Subject: Operations Maintenance Facility: East – Bulletin No. 0032

Bulletin No.	Description	Importance	Cost
0032	PCC Pavement at MOW	Normal	Unanticipated

PROJECT: LINK OPERATIONS & MAINTENANCE FACILITY: EAST**STANTEC PROJECT NO:** 204820133**DATE:** 12/12/2019**CONTRACT NO.:** RTA/CN 002-16**ORIGINATOR:** JIM MCPHERSON**DISCIPLINE:** CIVIL

Subject: Design bulletin DB032 for DP2 changes

DRAWING No.:
Y02-CRD130
LOCATION ID:
Y02
SHEET No.:
REV:
B

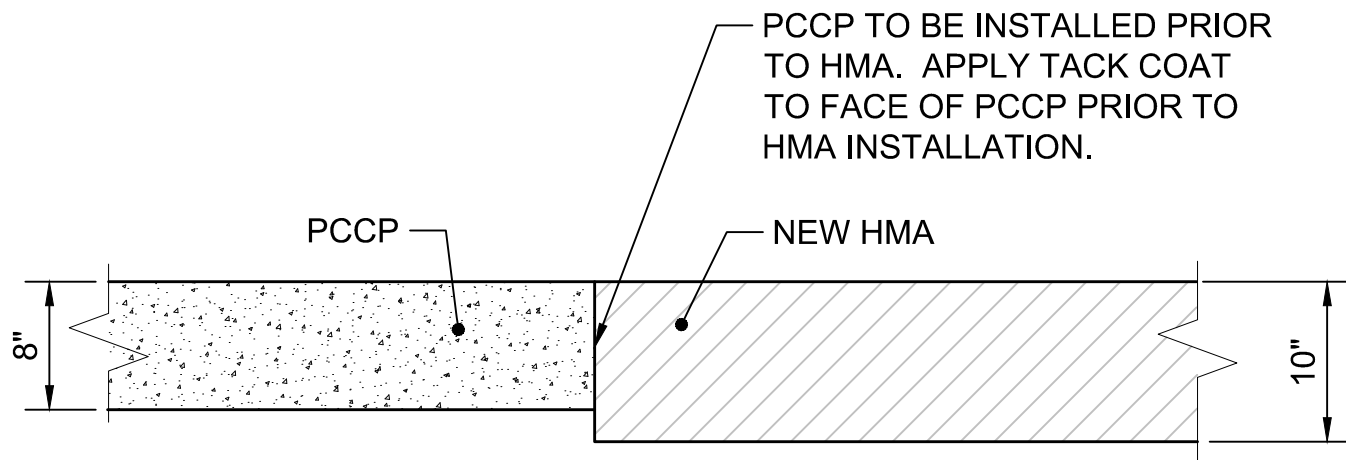
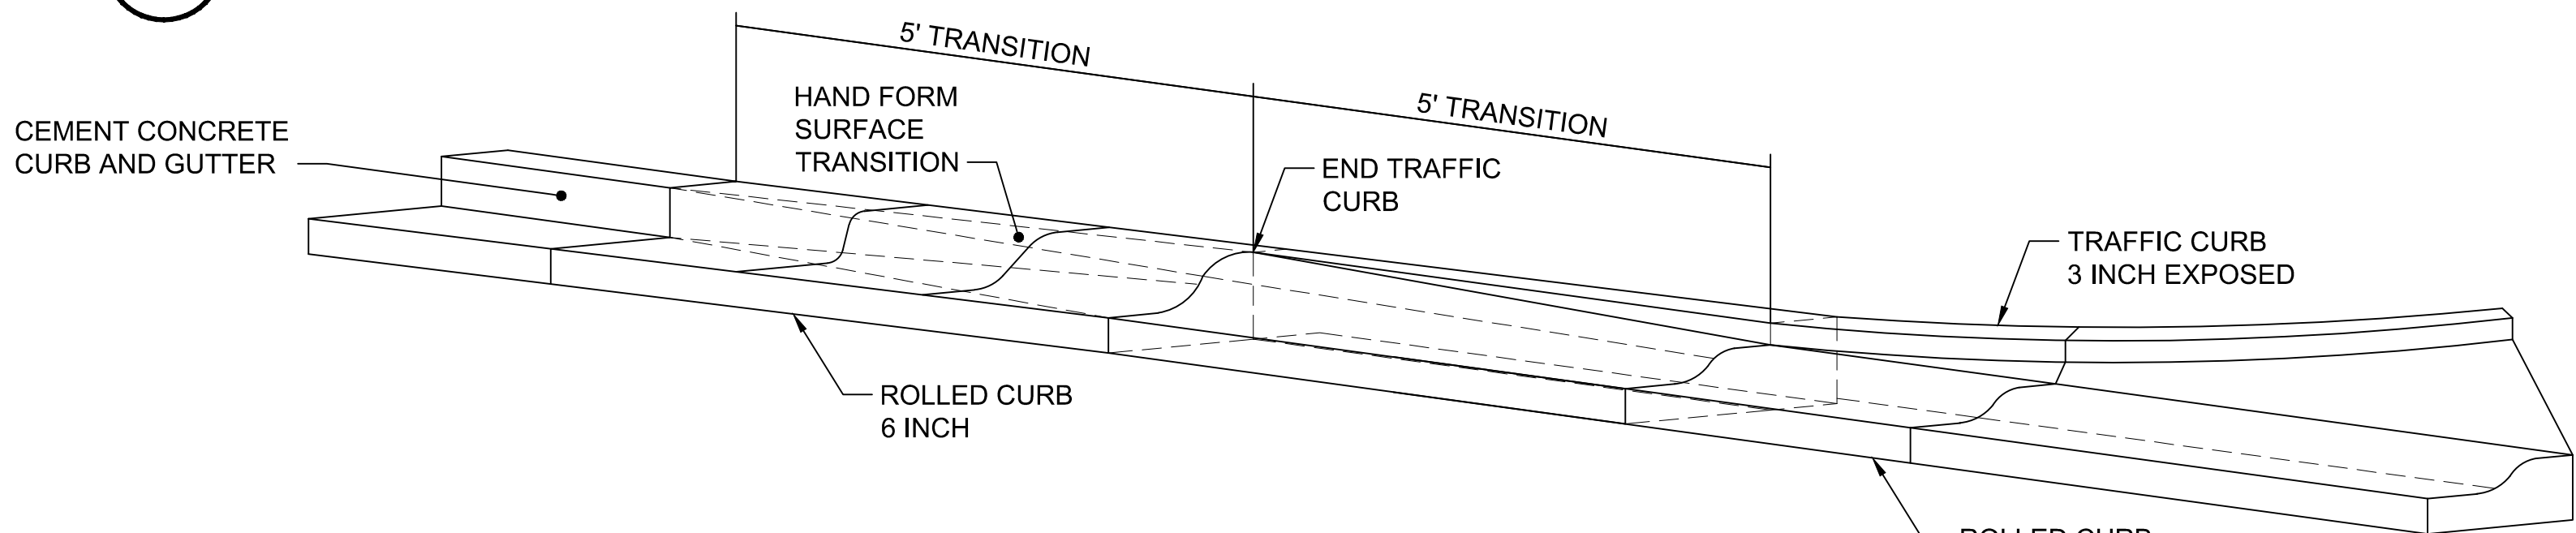
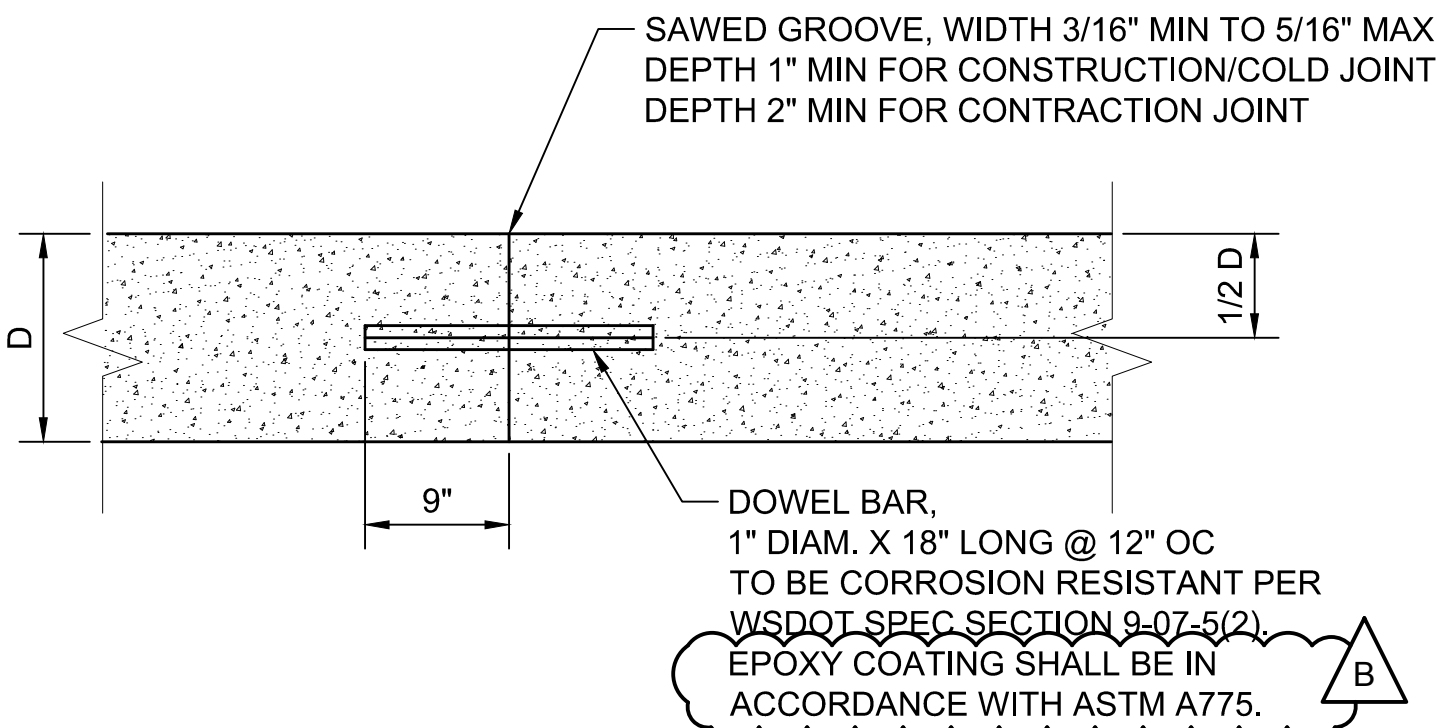
Y02-CRD130 – Update drawing to show PCCP (ADDED EPOXY COATING SPEC CALL-OUT)

DRAWING No.:
Y02-CRD147
LOCATION ID:
Y02
SHEET No.:
REV:
B

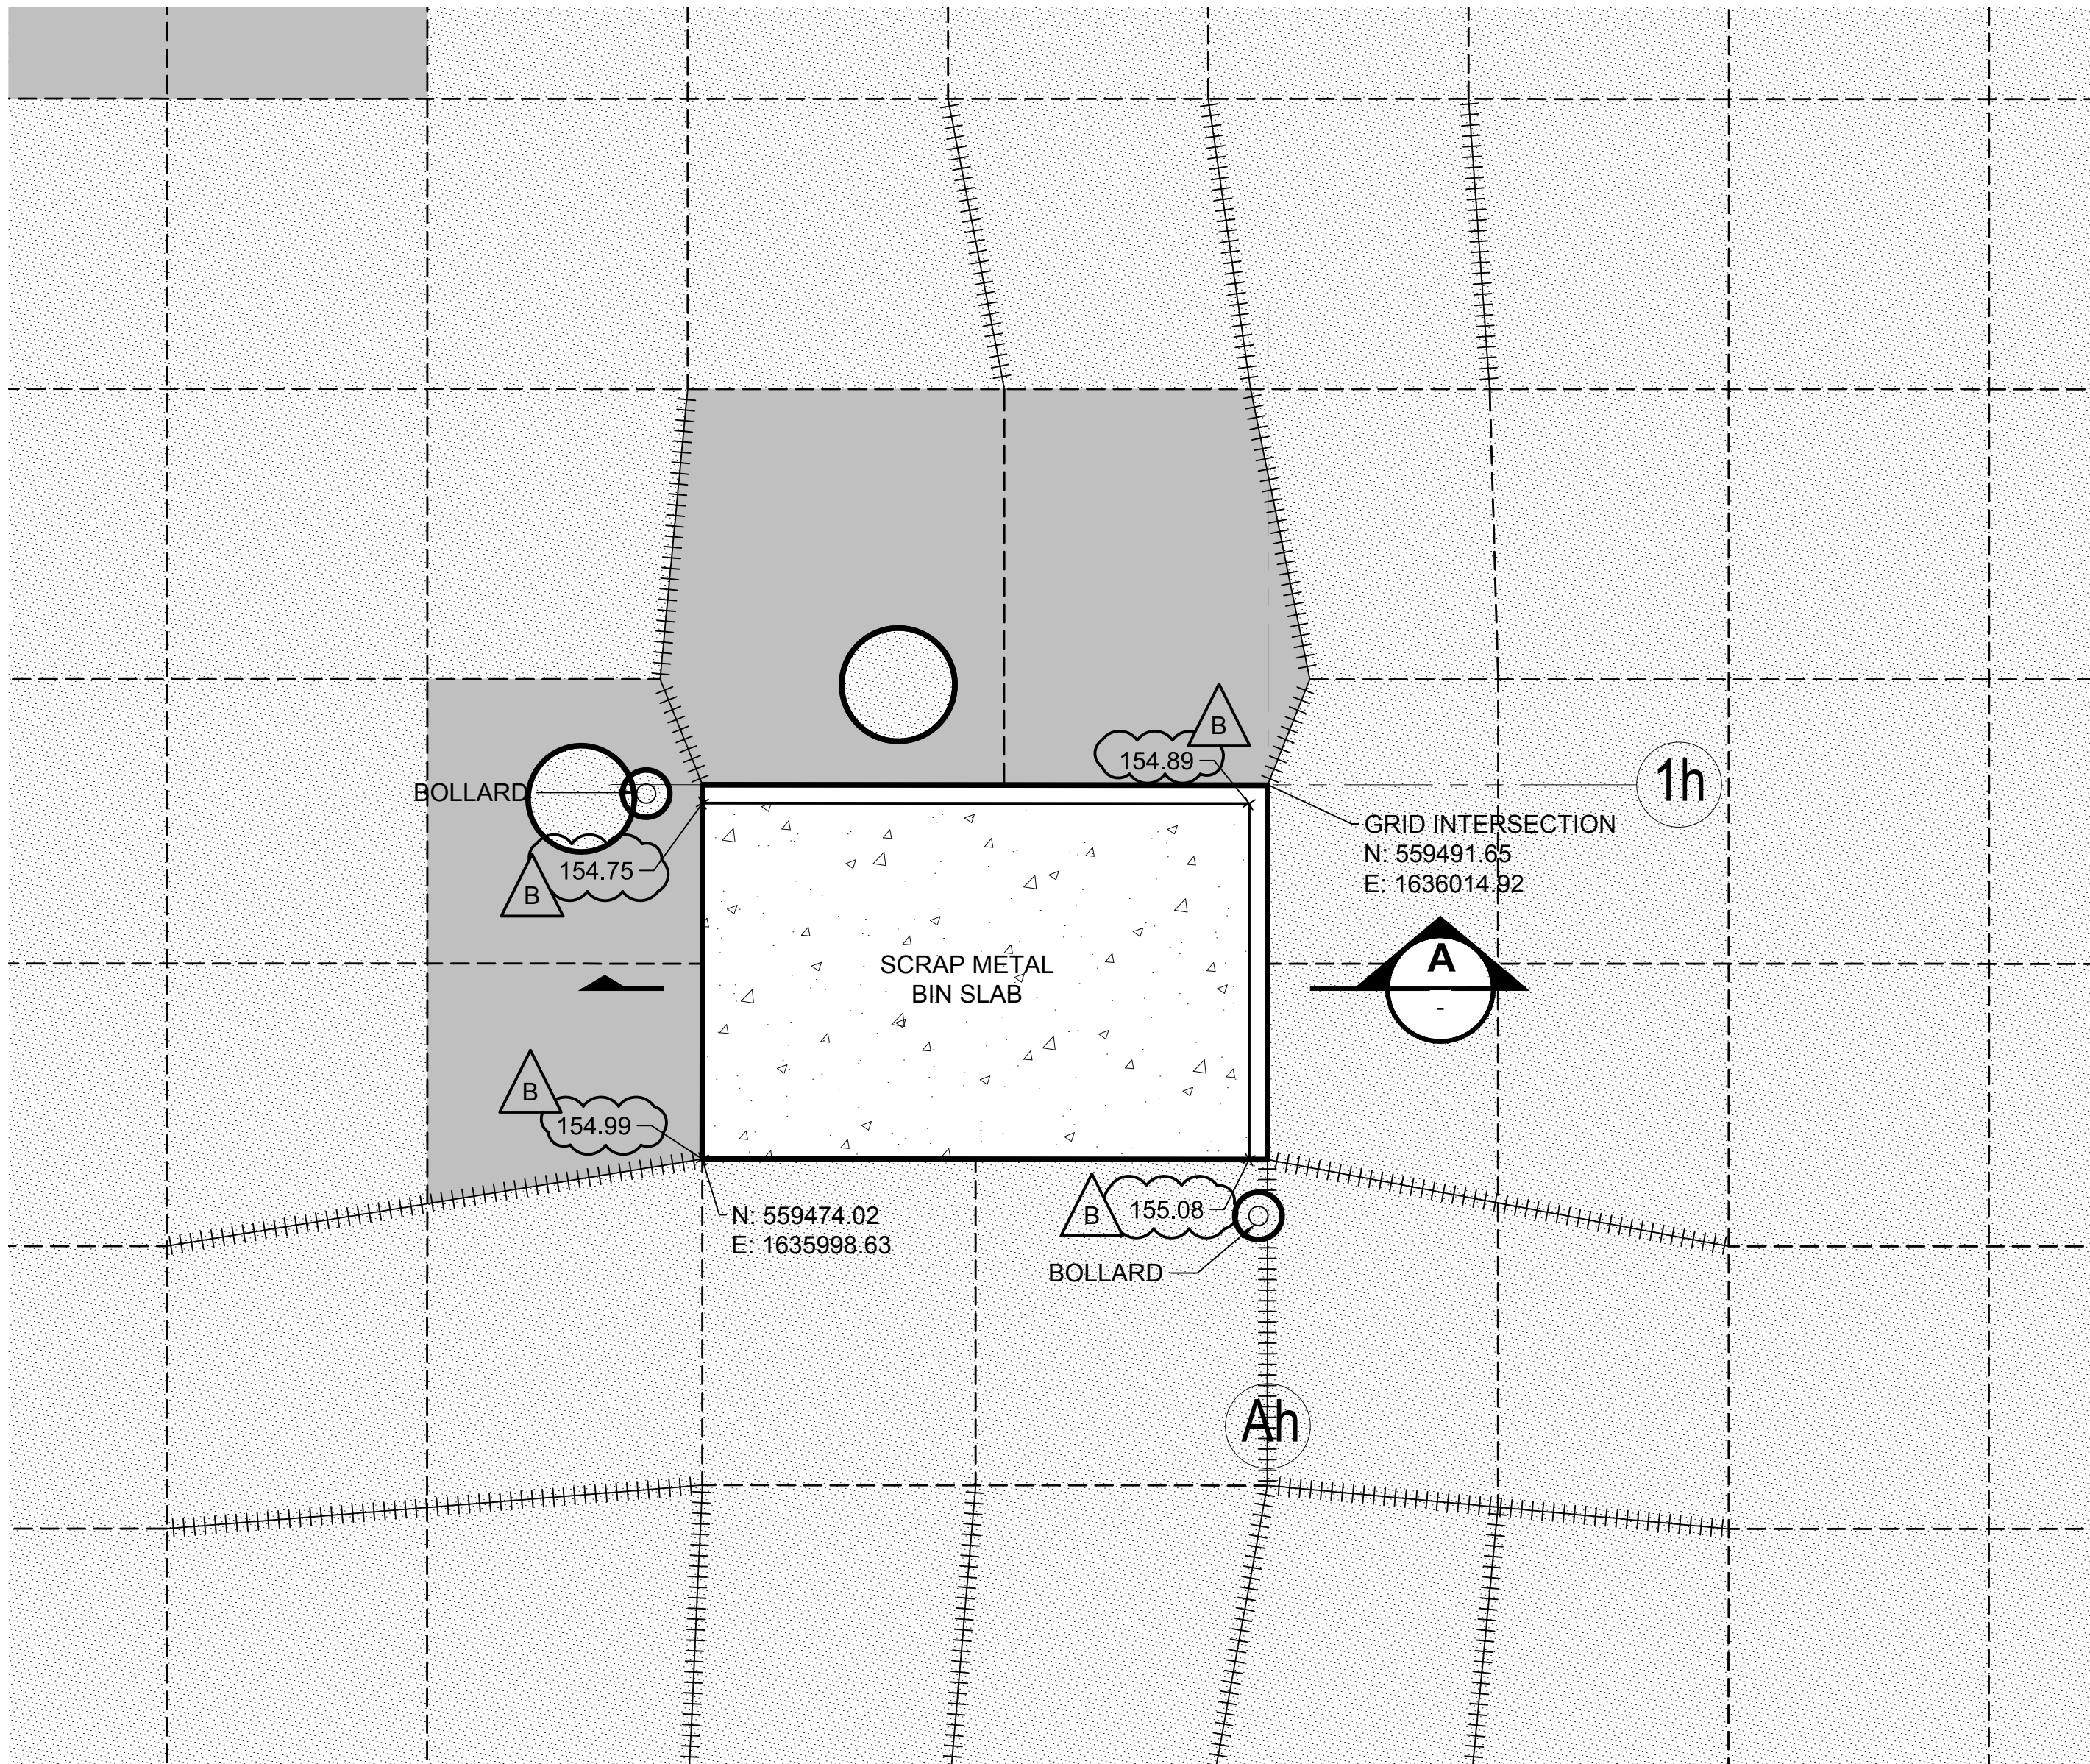
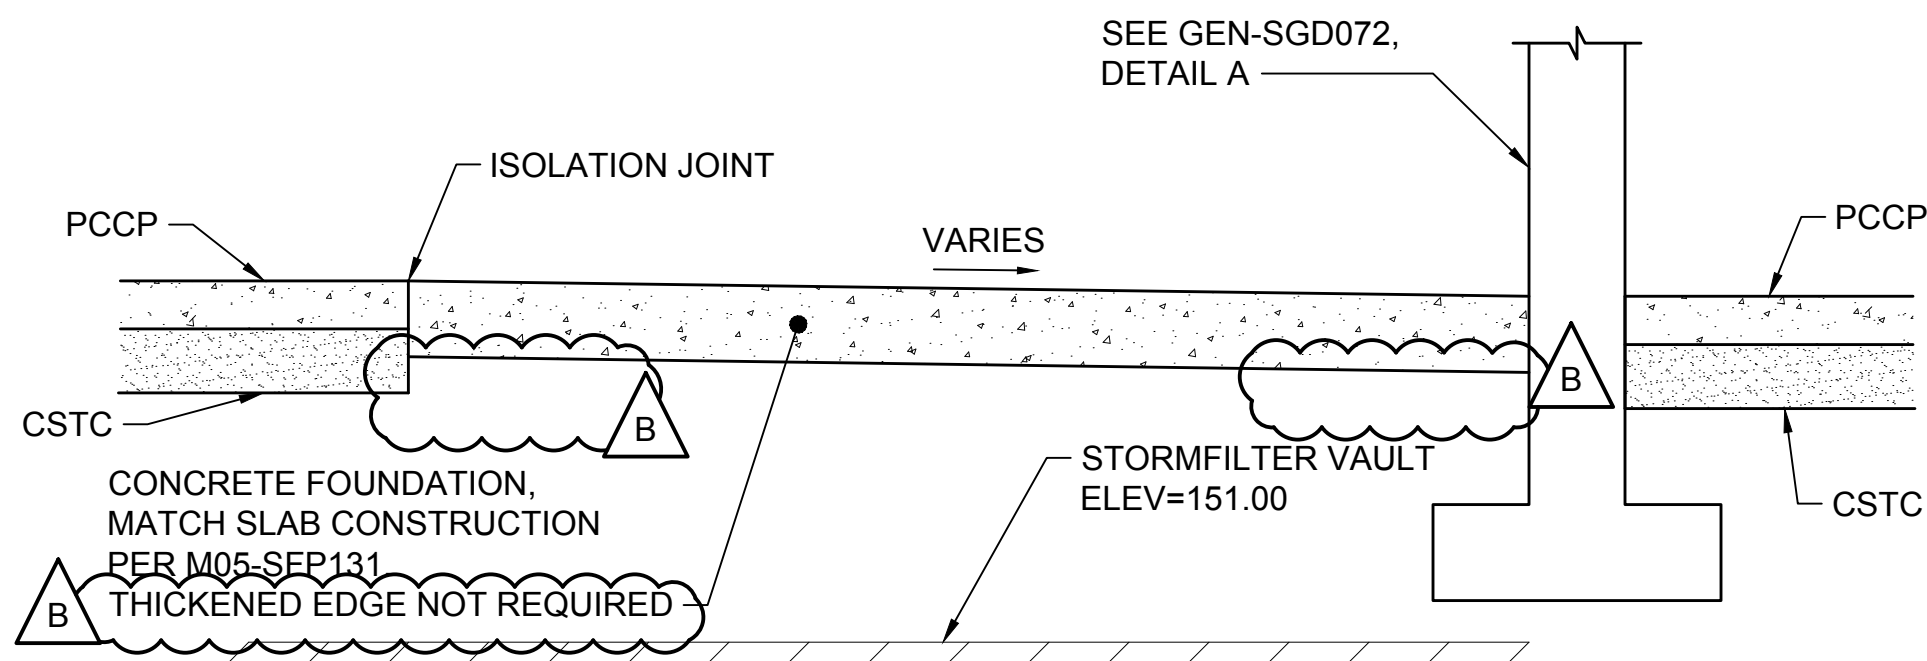
Y02-CRD147 – Update drawing to show PCCP (UPDATED ELEVATIONS)
